**REGULAR MEETING
VILLAGE OF BURR RIDGE
PLAN COMMISSION**

**April 18, 2016
7:30 P.M.**

Z-02-2016: 100 Harvester Drive (Hampton/Falls); Requests an amendment to Section IX.D.2 of the Burr Ridge Zoning Ordinance to add “Event Center” or a similar classification to the list of special uses in the O-2 Office and Hotel District and for special use approval as per Section IX.D.2. as amended of the Burr Ridge Zoning Ordinance for an amendment to the Estancia Planned Unit Development, Ordinance No. A-834-08-04 to permit development and use of a four-story hotel and a one-story event center rather than the previously approved four-story office building with a parking deck.

V3 Site Plan

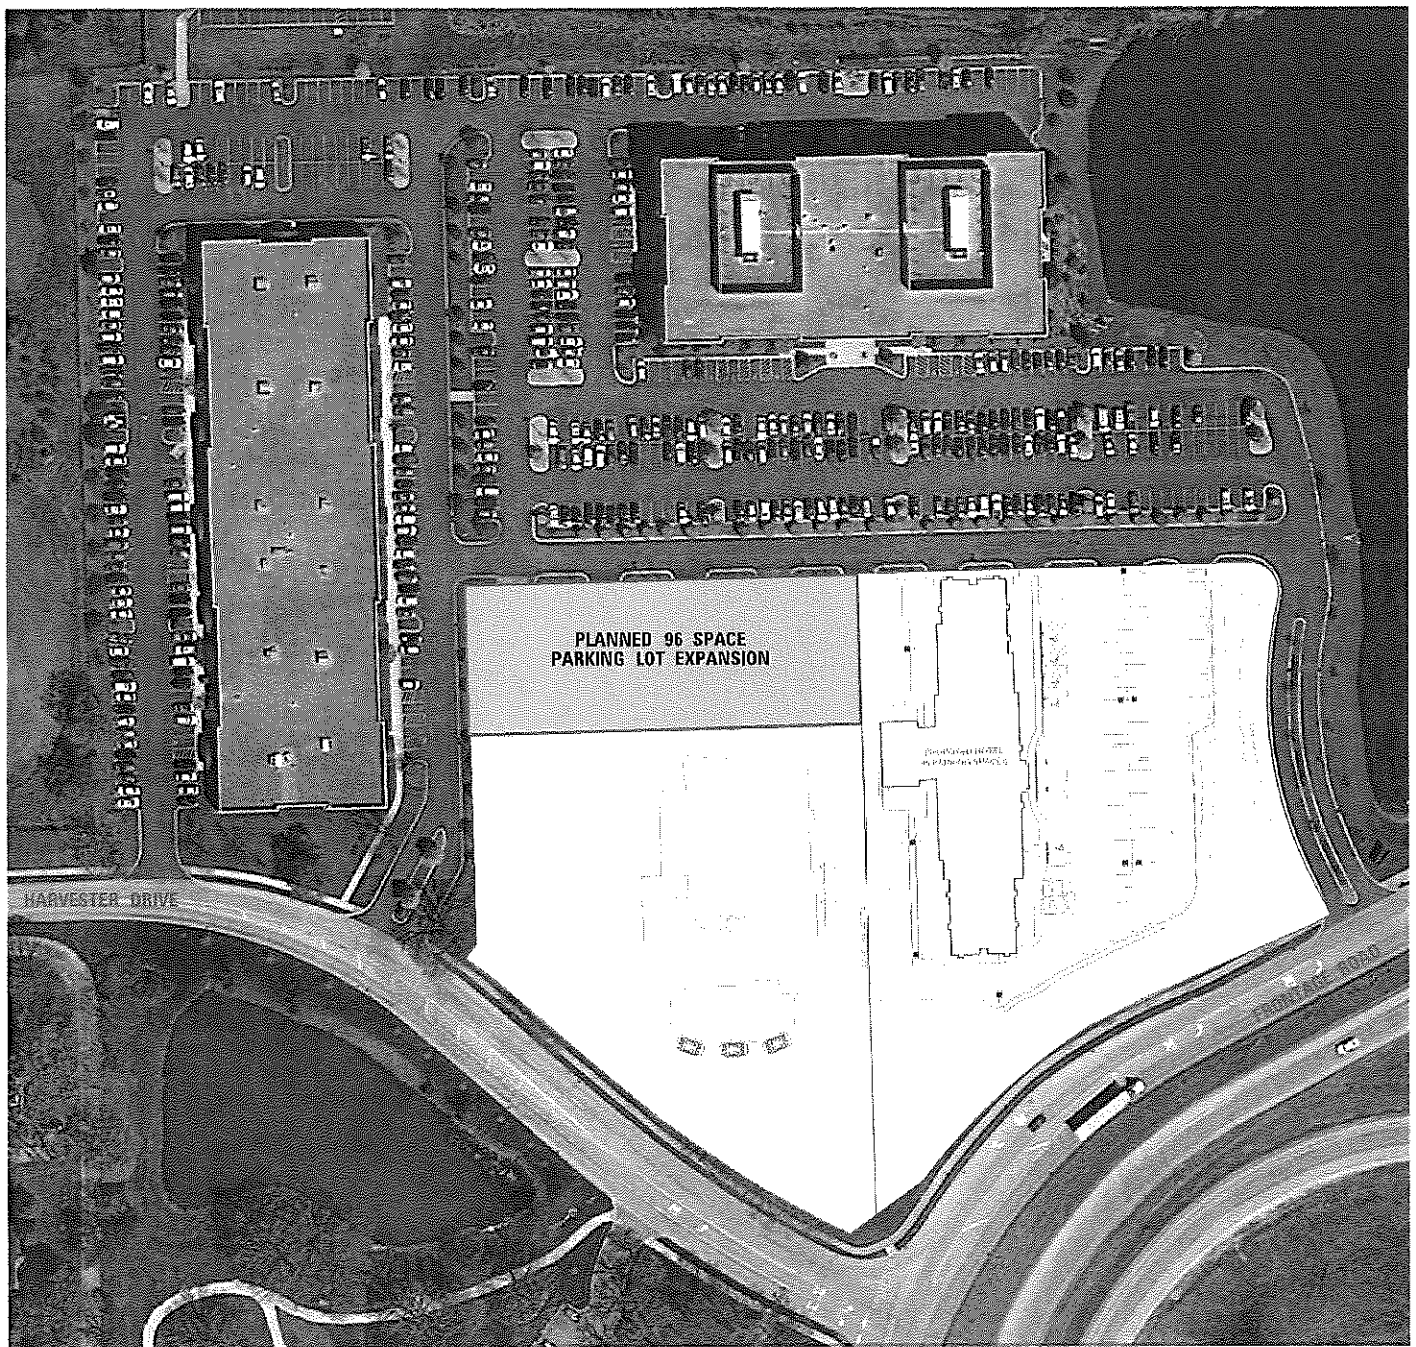
4. The V3 site plan indicates that the event center has a maximum capacity of 700 people. More information is needed to justify that only 10-20% of the event center will be used on a regular basis during the weekday daytime and evening.

6. On a bookkeeping note, Appendix B was the CMAP letter regarding traffic growth. Please provide the "Event Space – Similar Site Operations" information.

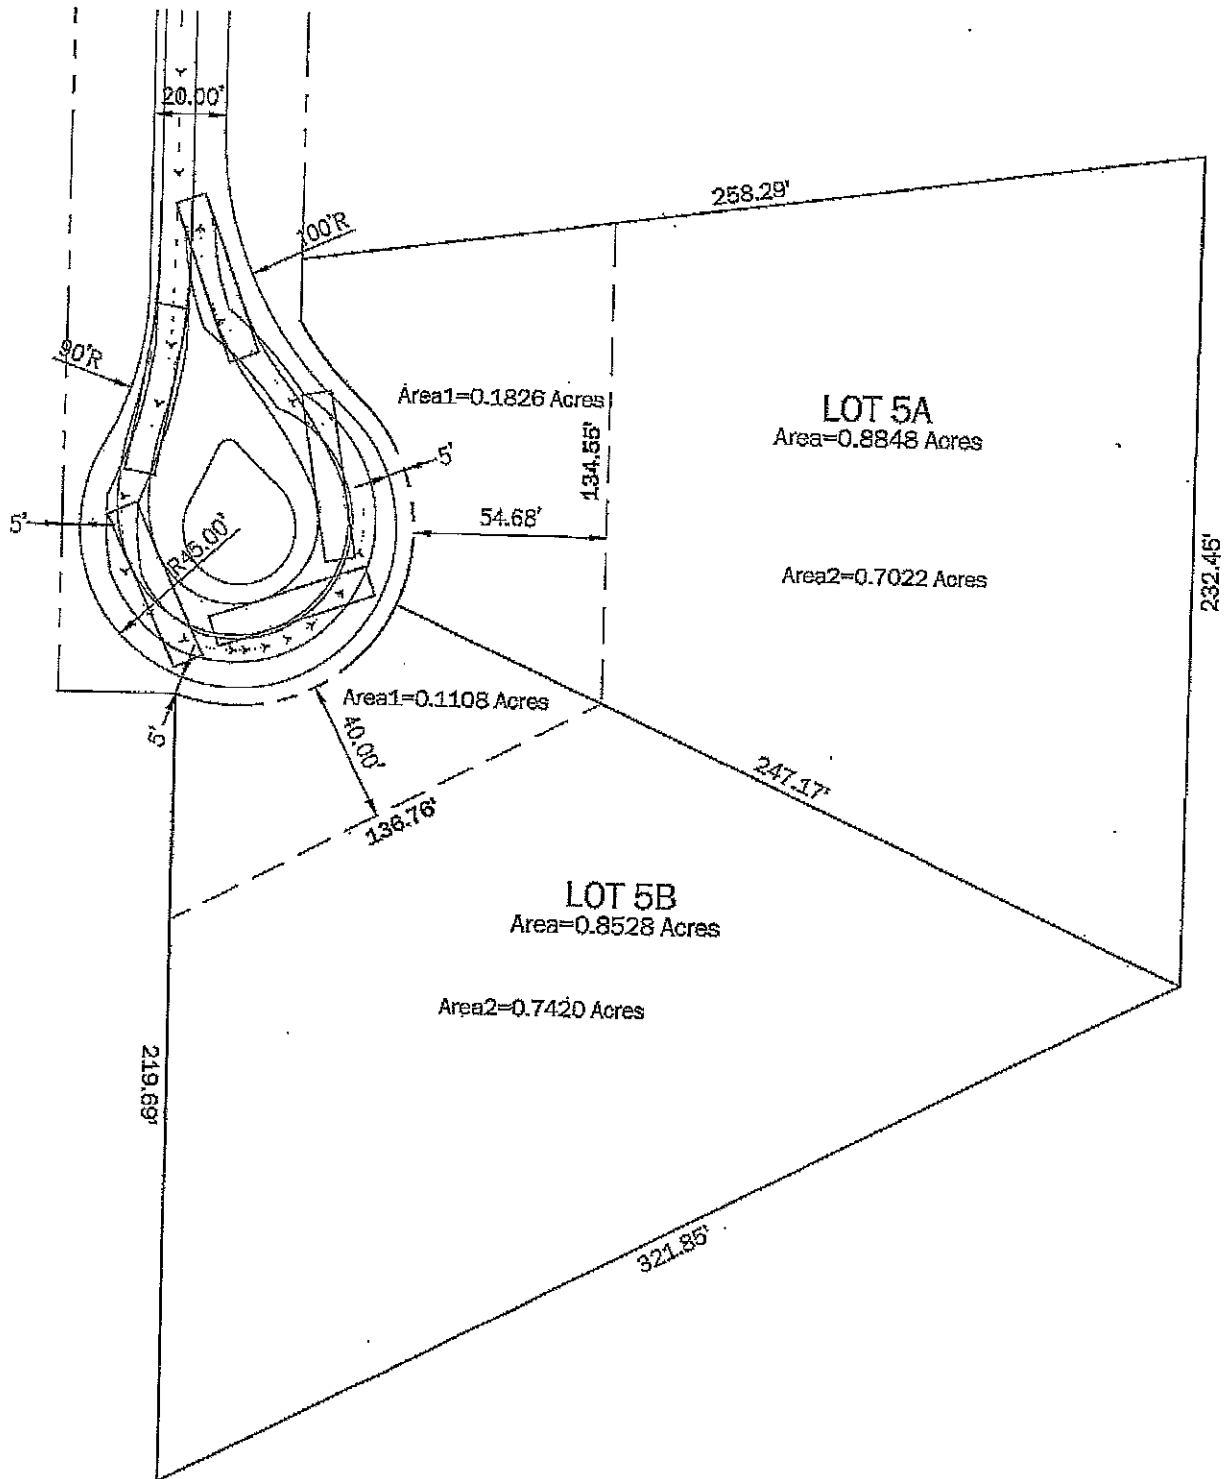
turnaround is proposed. The turnaround would provide the required pavement width (45 foot radius) but would not provide the required right of way width (60 foot radius required, 50 foot radius proposed).

- The name of the subdivision is proposed as Esther Court. Since the street is already named Drew Avenue, inclusion of “court” in the name may be misleading.

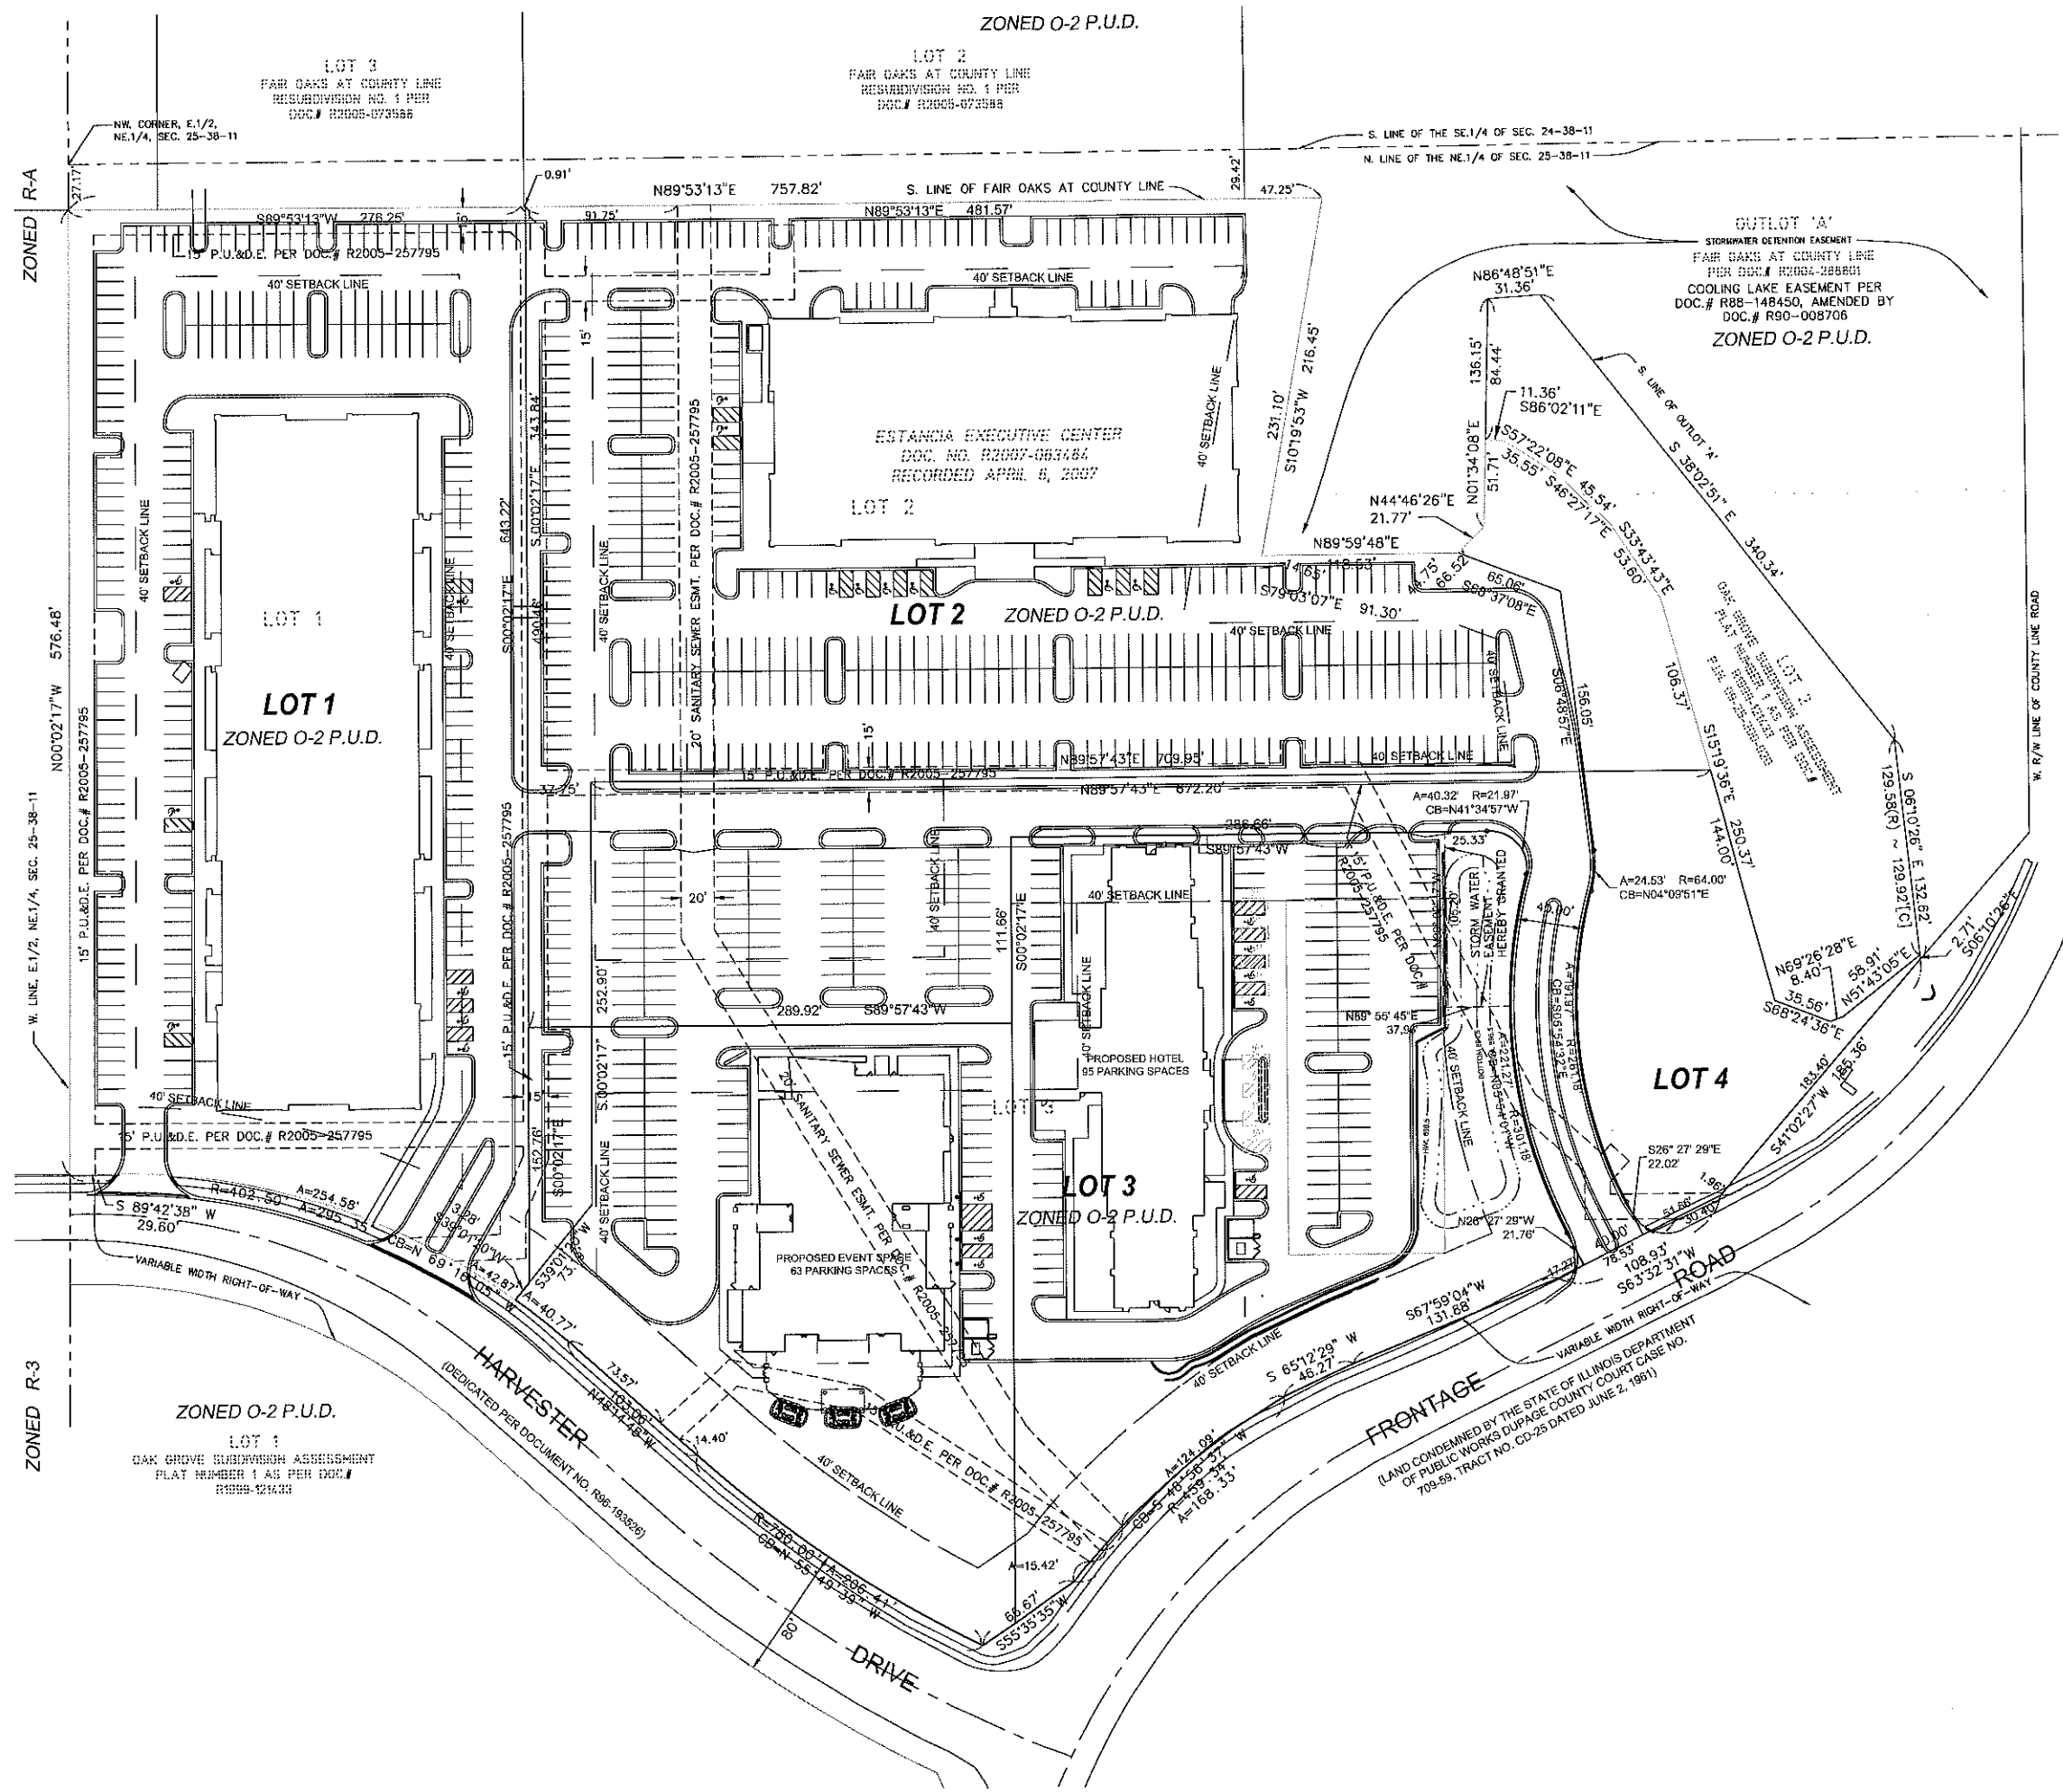
The following are review comments for the subject development preliminary engineering Site Improvements plans January 10, 2016:

3. A tree survey and demolition plan will be required.
4. Proposed street profile grade and cross-slope labels will be required.
5. Streets shall be constructed with IDOT type B6.12 curb and gutter. This also affects stormwater conveyance system.
